5DX-82-S

S E R V I C E N O T E

Agilent 5DX Series 2L, Series 3, and Series 5000 Systems

The E1135A/B/C PDU may not turn off when the EMO switch (emergency stop) is pressed.

Fig 1

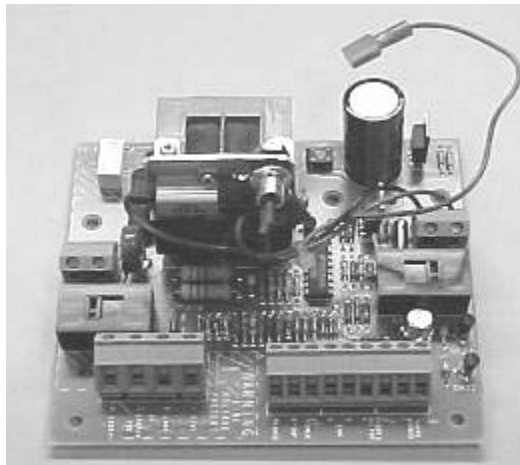
Investigations revealed that the DC voltage supplied to the 0490-2318 from the E1135-66501 control board was higher than specified as there was no voltage regulation. Over time, excess heat can damage the coil of the magnetic contactor which leads to the described safety hazard.

The solution is to replace the E1135-66501 control board in the PDU with a newer version (Fig 1) that incorporates a voltage regulator to the magnetic contactor.

Fig 11

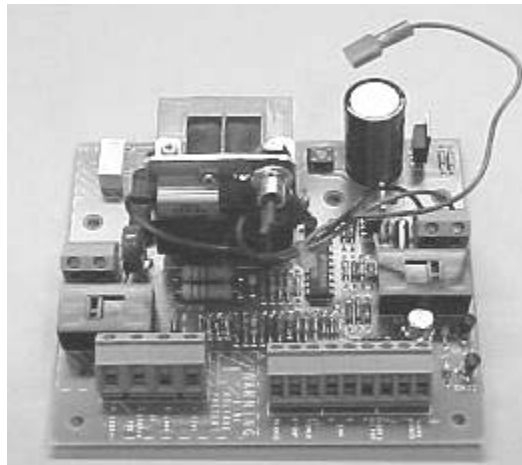
12. Remove the old control board from the PDU and discard.
13. Install the new control board (Fig 11) into the PDU using the five M4 Torx screws removed in step 12. Tighten these screws using a T20 Torx driver and torque to 16 inch-lb (1.81 n-meter)

Fig 12

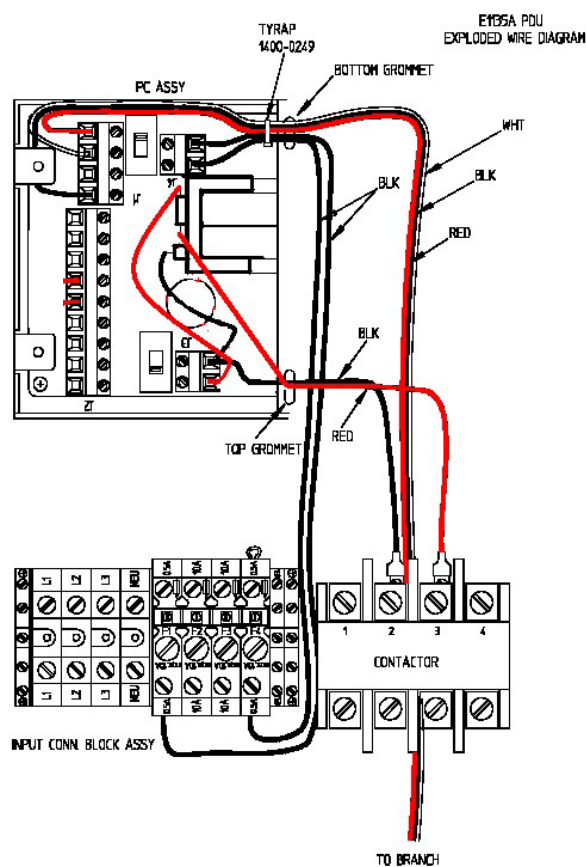
14. Re-wire the control board using the wiring diagram in Figure 12 and wires removed from J2 on the control board in step 9.

Control Board to Contactor Connections		
Black Wire Contactor Pin 2	to	Control Board J3 pin 2
Black Wire Control Board J3 pin 2	to	Regulator on Control Board
Red Wire Contactor Pin 3	to	Regulator on Control Board
Red Wire Control Board J3 pin 1	to	Regulator on Control Board

Note: Wires from Regulator to J3 on control board are already connected when received from SPD.

Fig 13

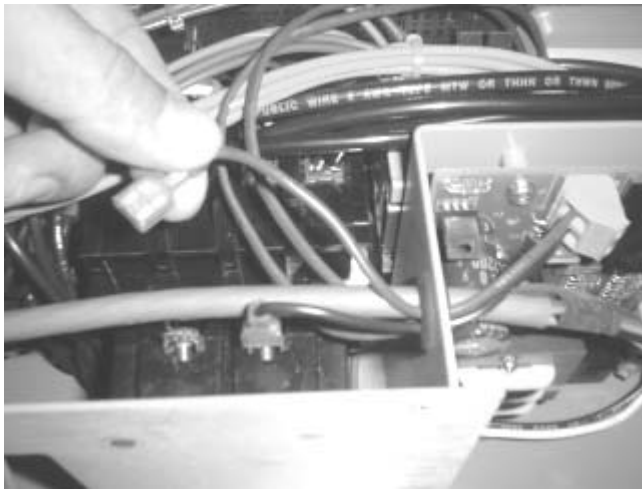
15. Figures 13, 14 and 15 show the new control board wiring.
